**Proposal for the 03 series of amendments to Regulation No. 34
(Fire prevention)**

A. PROPOSAL

Annex 2 Model B, amend to read:

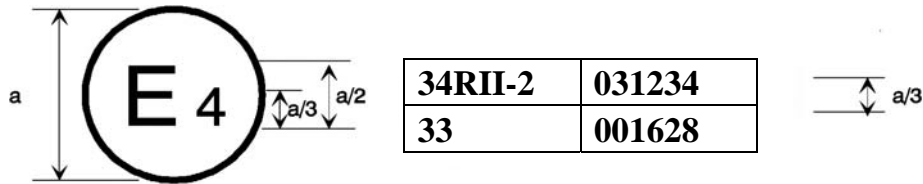
The above approval mark affixed to a vehicle shows that the type concerned was approved in the Netherlands (E4) pursuant to Regulations Nos. 34 Parts I or IV and II-1 and 33 */. The approval numbers indicated that, at the date when the respective approvals were given, Regulation No. 34 included the ~~02~~ 03 series of amendments and Regulation No. 33 was still in its original form.

The above approval mark affixed to a vehicle shows that the type concerned was approved in the Netherlands (E4) pursuant to Regulations Nos. 34 Parts I or IV and II-2 and 33 */. The approval numbers indicated that, at the date when the respective approvals were given, Regulation No. 34 included the 03 series of amendments and Regulation No. 33 was still in its original form."

Based on the justifications for paragraph 1.2. above, Japan proposes to amend the approval number provisions and approval mark models.
